SERVICE LETTER

No. 138

Piper Aircraft Corporation

SUBJECT: Rudder Pedal Tube Attachment

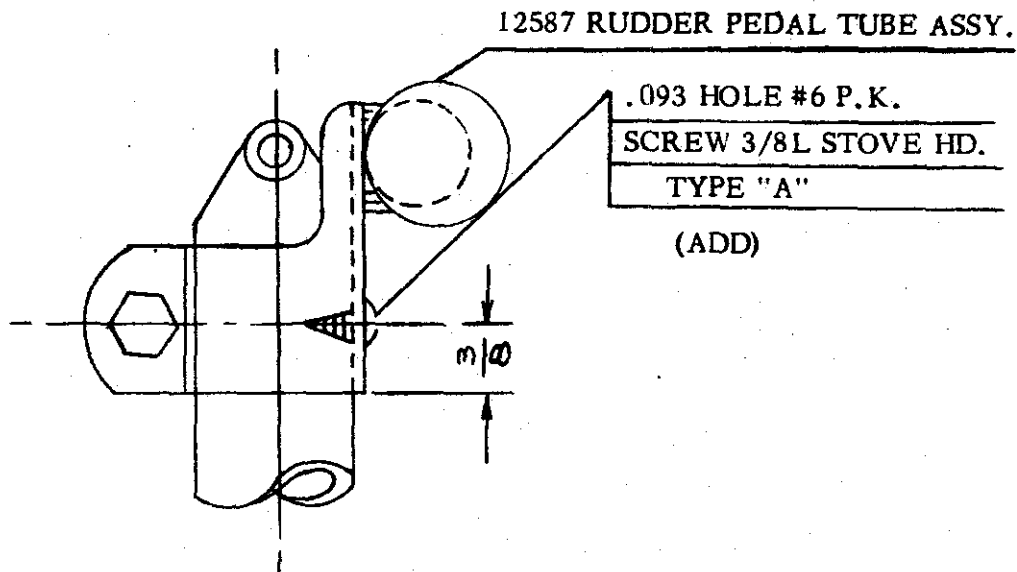
It is recommended that a #6 x 3/8" Parker Screw be installed in the rudder pedal tube clamp of the right hand rudder pedals to eliminate the possible rotation of the rudder pedal cross tube on the torque tube arm. The Parker screw should be installed, as per sketch shown below.
